Letter of OBJECTION

Planning Application Number APP/17/00358

Land west of Horndean Road and south of Southleigh Road

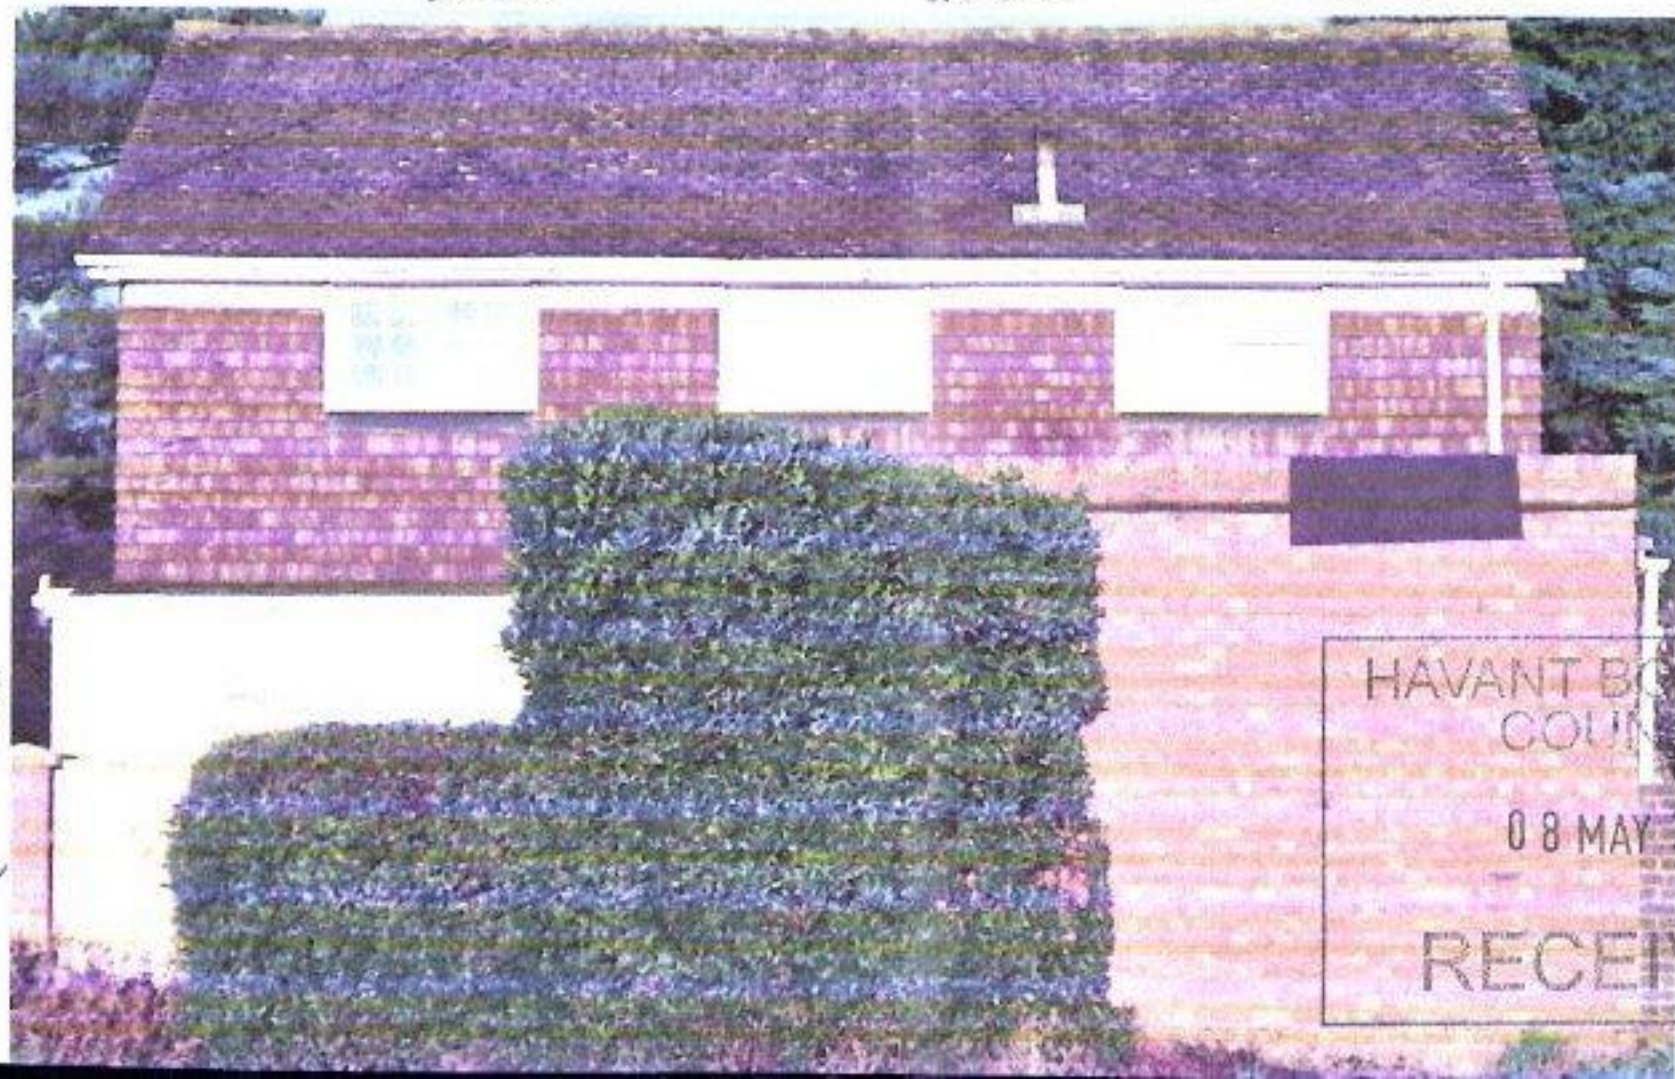
1. The 5m buffer zone of planting on the eastern boundary that was shown on the approved outline planning application - I refer you to APP/14/00547 Illustrative Master Plan 055-PL-03 Rev A - is not provided for in the new plan which impacts considerably on my privacy. There was at least 22m between the fronts of the houses and my kitchen/diner window on the approved plan (scaling from the plan). On the new proposal - I refer you to APP/17/00358 Coloured Site Layout 16386/C101A - the backs of the houses (plots 57-61) are shown approximately 14.5m from my boundary and Plot 57's windows will be approximately 15m from my kitchen/diner window so they will be looking directly into my window. This distance could also potentially be reduced even more if the occupants decide to build an extension on the rear in the future. I'm also concerned that Plots 59-62 would also be able to look into the back windows of my house. Furthermore, my living room wall is directly on the boundary with the rear gardens so I am very concerned that this wall will become a 'ball wall' !! I am also concerned about maintaining access for maintenance of my property on the adjoin boundary.

The new proposal shows complete insensitivity and has no respect whatsoever for my privacy as well as for the ecological enhancements mentioned in the approved documents. I strongly request that the 5m buffer zone that is in the approved documents should be respected.

← Large
diner
window

↓
bedroom
window

↓
bathroom
window

↓
bedroom window

→
kitchen/
diner
window

SHAW - 57 HORNDEAN ROAD

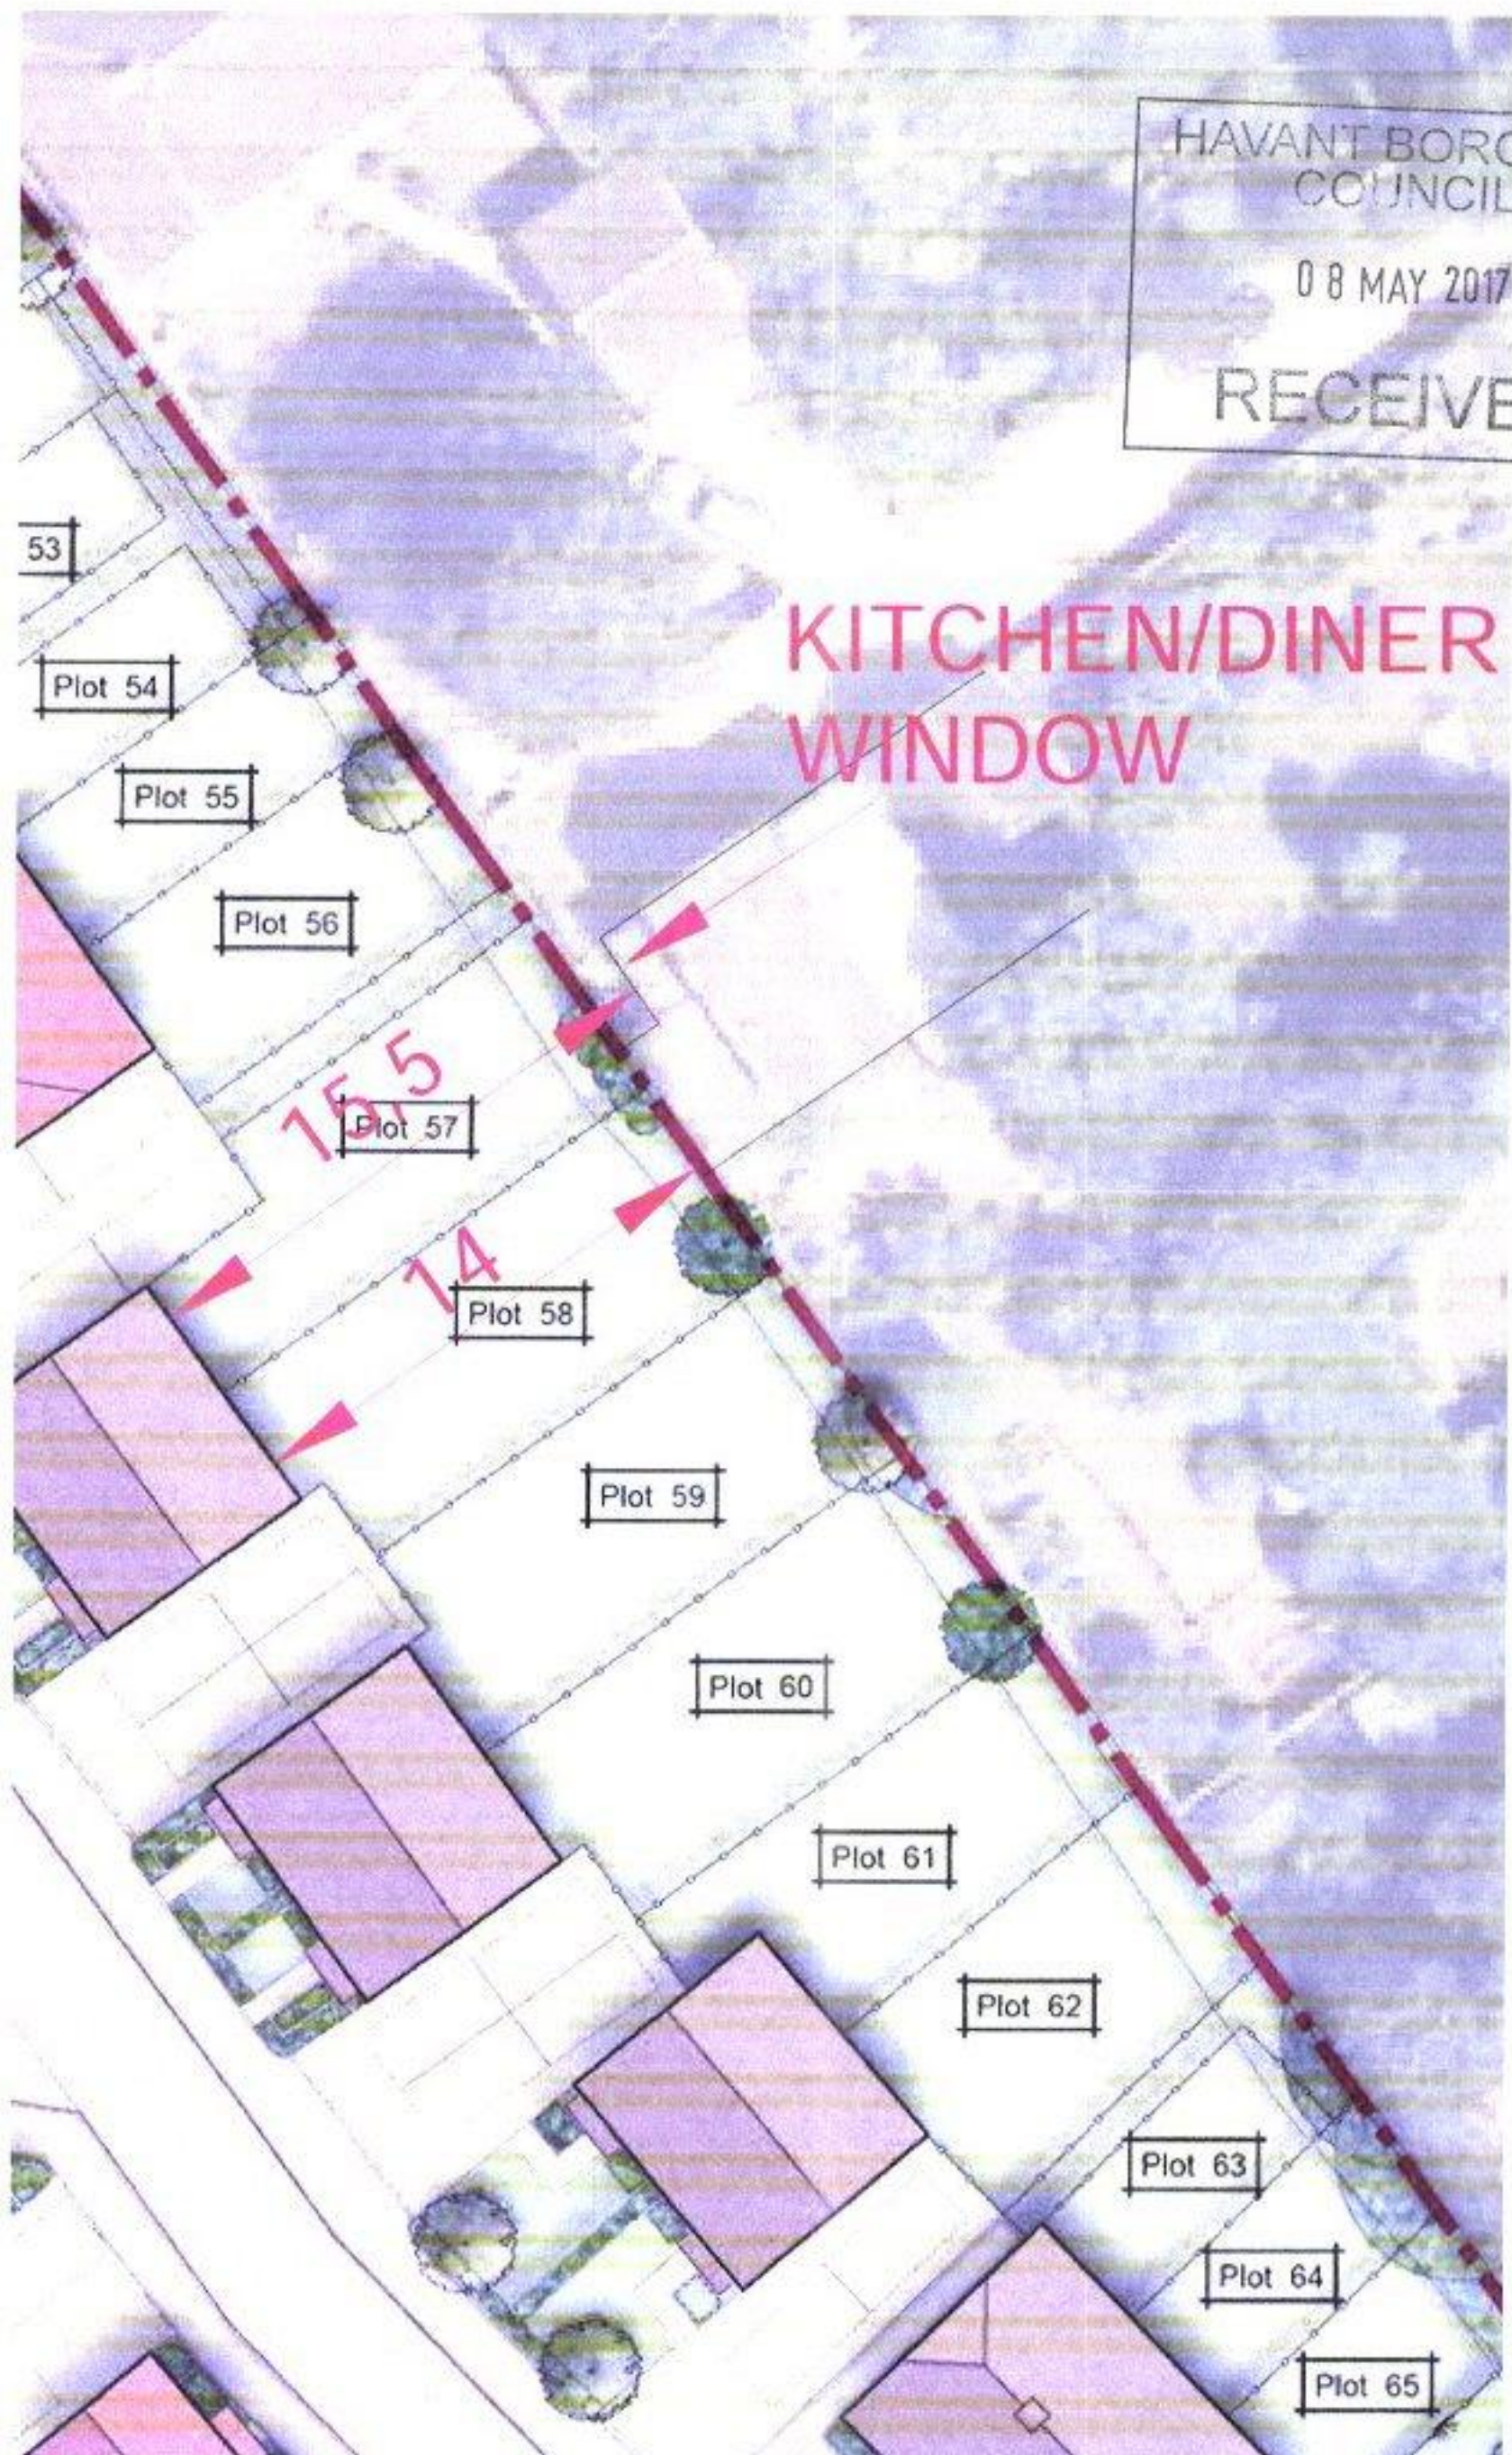
2. There is a 'footpath' shown on the new proposal, between Plots 56 & 57, which terminates at the end of the private access lane to the front of my property. I am very concerned that this will become a shortcut for those who are prepared to climb over the gate. This access road is not a public highway and maintenance costs for the current residents would escalate if the road was being continually used as a short cut to the Horndean Road by opportunists. I therefore request that there should be no encouragement for people to take this route.
